Response to Objection to Outline planning permission for Extension of MIRA Technology Park

Technical Note

Document Reference: EED13833-118-TN-6-1-1

PROPOSAL: Outline planning permission for Extension of MIRA Technology Park to comprise employment use (Class B2); associated office and service uses (Class Eg); storage (Class B8); new spine road; car parking, landscaping and enabling works - All matters reserved

Figure 1 Extract of the Drawing Number 13833-WIE-ZZ-XX-DR-92004 Revision P05

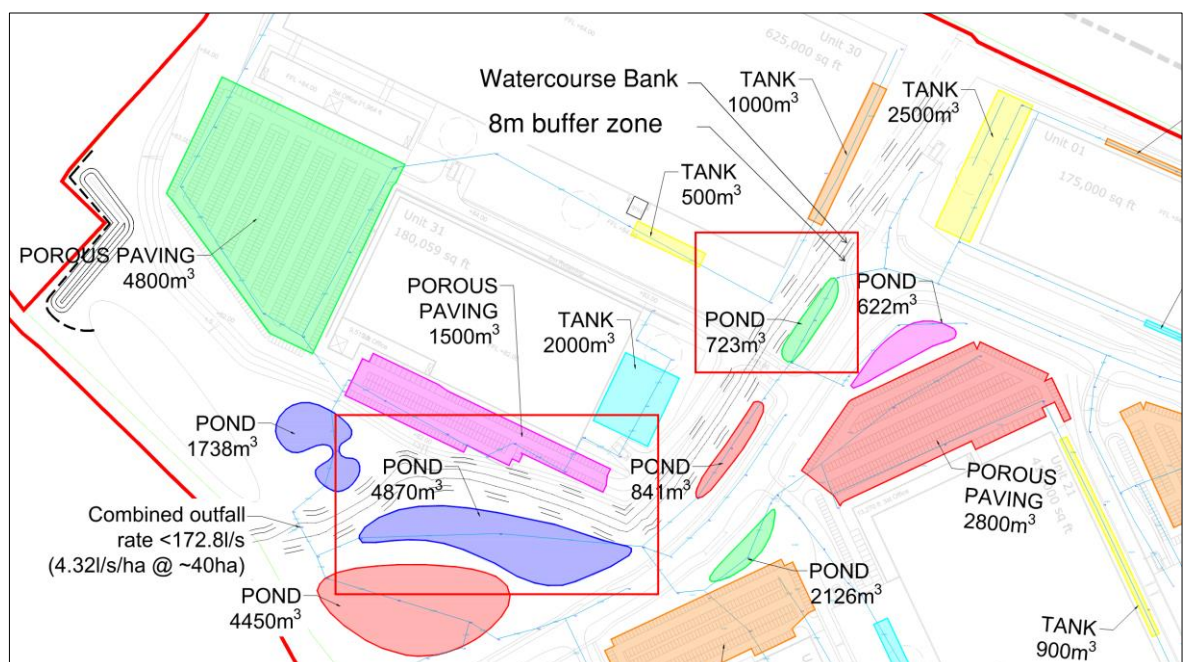
The previously submitted technical note (EED13833-118-TN-3-1-3) stated in paragraph 1.16 that two of the previously proposed ponds would not provide the full 8m easement from the watercourse on site, and therefore the drainage strategy would be revised to provide swales instead. The technical note recently submitted (EED13833-118-TN-5-1-2) does not reflect these changes and the drainage strategy remains unchanged. The LLFA therefore maintains their request for further details of a revised drainage strategy that honours the 8m easement and performs effectively. The LLFA requests:

- a. A revised Indicative Surface Water Drainage Strategy that reflects the above changes to illustrate the nature and layout of the proposed drainage features.
 - b. Calculations to demonstrate that there is adequate attenuation to limit the site's discharge to the appropriate greenfield run off rate of 4.32l/s/ha.

1. The previously submitted technical note (EED13833-118-TN-3-1-3) stated in paragraph 1.16 that two of the previously proposed ponds would not provide the full 8m easement from the watercourse on site, and therefore the drainage strategy would be revised to provide swales instead. The technical note recently submitted (EED13833-118-TN-5-1-2) does not reflect these changes and the drainage strategy remains unchanged. The LLFA therefore maintains their request for further details of a revised drainage strategy that honours the 8m easement and performs effectively. The LLFA requests:

- 1.3. As part of the revised drainage strategy EED13833-118-TN-5-1-2, the two ponds were realigned to fall outside the 8m buffer zone (easement) instead of replacing them as swales. The reason for doing this is that the buffer required for the two ponds was not far off from the requirement of 8m easement. Swales shall be investigated as a proposal as part of the detailed scheme design if still required. As part of outline planning application, the drainage strategy demonstrates there is sufficient space allowed for storage by retaining pond solution as such without needing them to replace with swales.

- 1.4. Figure 1 below highlights the two ponds in red box that were realigned outside of the 8m easement. This is an extract of the Drawing Number 13833-WIE-ZZ-XX-DR-92004 Revision P05 from the Appendix B of EED13833-118-TN-5-1-2 submitted in support of the drainage strategy.

- 1.5. Based on the above, it is understood that the revised Indicative Surface Water Drainage Strategy and the calculations submitted as part of the technical note EED13833-118-TN-5-1-2 reflects all the changes and is sufficient to overcome the objection.
